January 24, 2003  
L-03-004

**Subject: Beaver Valley Power Station, Unit No. 1 and No. 2**  
**BV-1 Docket No. 50-334, License No. DPR-66**  
**BV-2 Docket No. 50-412, License No. NPF-73**  
**Reply to Request for Additional Information Regarding**  
**60-Day Response to Bulletin 2002-01**

### **Reply to Request for Additional Information Regarding Beaver Valley Power Station (BVPS) Units 1 and 2 60-Day Response to NRC Bulletin 2002-01 “Reactor Pressure Vessel Head Degradation and Reactor Coolant Pressure Boundary Integrity”**

Figure 4A

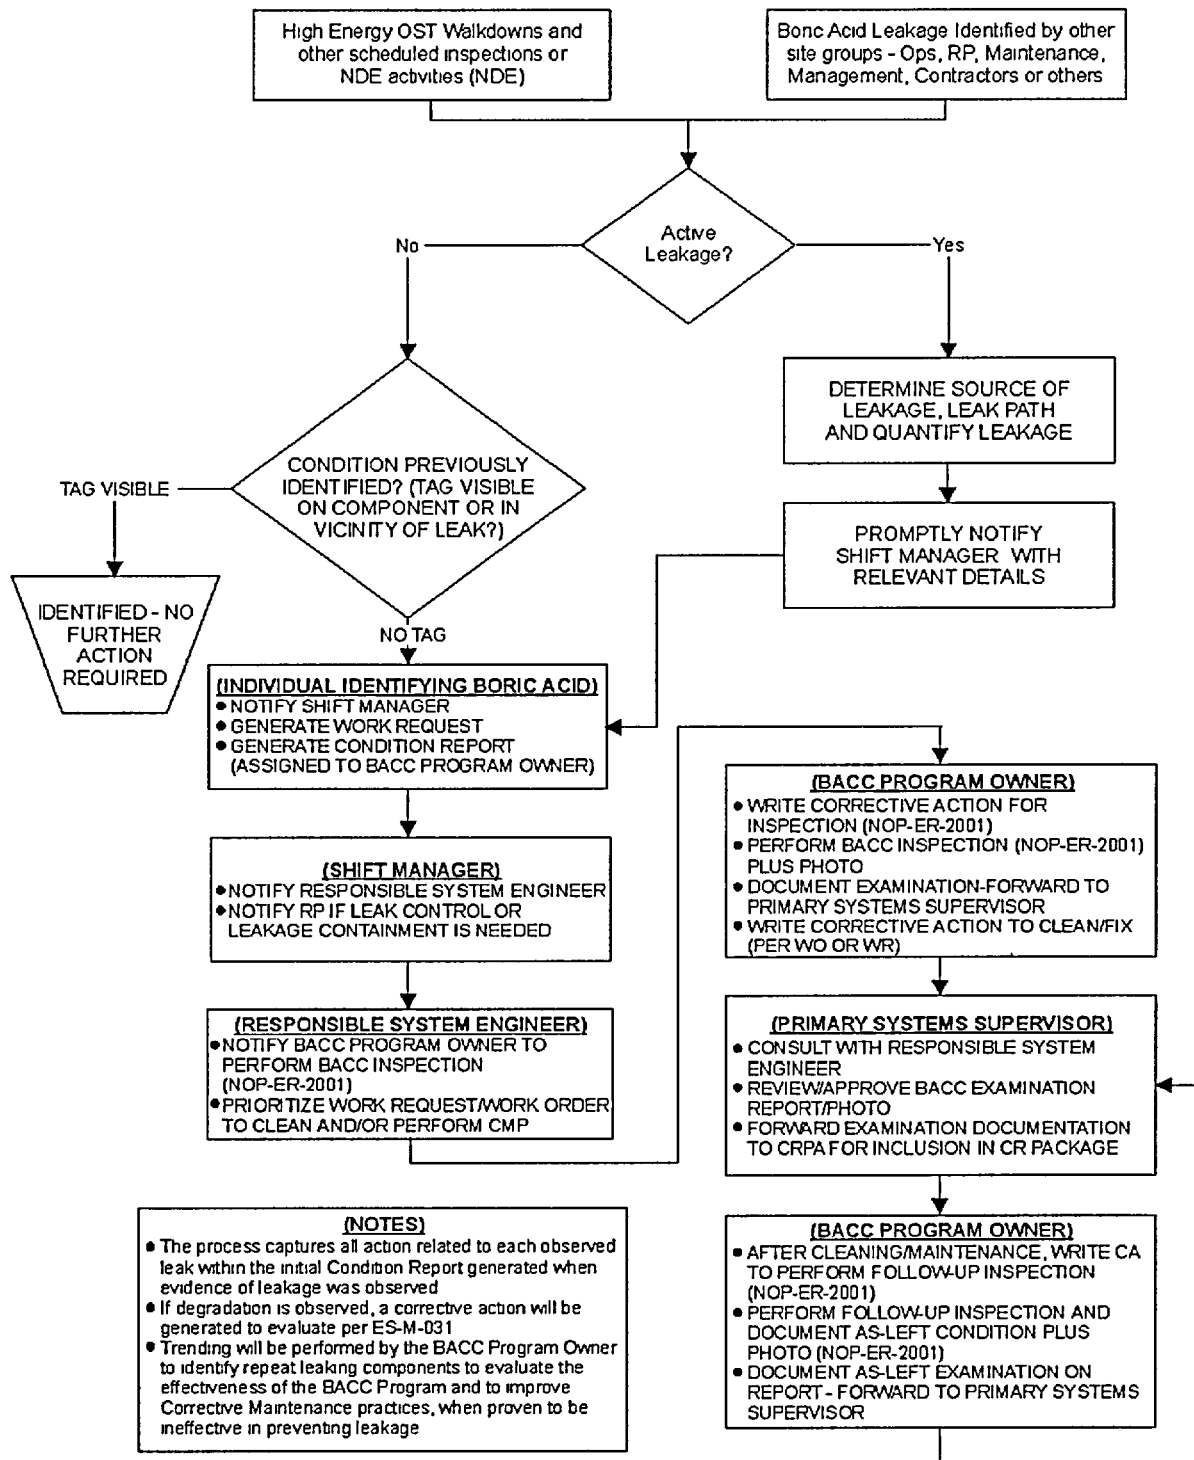
4. ***Describe the evaluations that would be conducted upon discovery of leakage from mechanical joints (e.g., bolted connections) to demonstrate that continued operation with the observed leakage is acceptable. Also describe the acceptance criteria established to make such a determination. Provide the technical basis used to establish the acceptance criteria. In addition,***
- a. ***if observed leakage is determined to be acceptable for continued operation, describe what inspection/monitoring actions are taken to trend/evaluate changes in leakage, or***
  - b. ***if observed leakage is not determined to be acceptable, describe what corrective actions are taken to address the leakage.***

Boric acid leakage process flow charts were developed for inclusion in 1/2-ADM-2112, "Boric Acid Corrosion Control," and are attached for your information (see Figures 4A and 4B). These flow charts clearly identify the process and the actions to be taken.

If the observed leakage is determined to be acceptable for continued operation, the actions and monitoring for trending and evaluating are described in our procedure 1/2-ADM-2112. A summary of the process is provided in the attached flowcharts (see Figures 4A and 4B).

### PROCESS FLOW CHART FOR EXAMINATIONS OUTSIDE RCB (Attachment A of 1/2-ADM-2112)
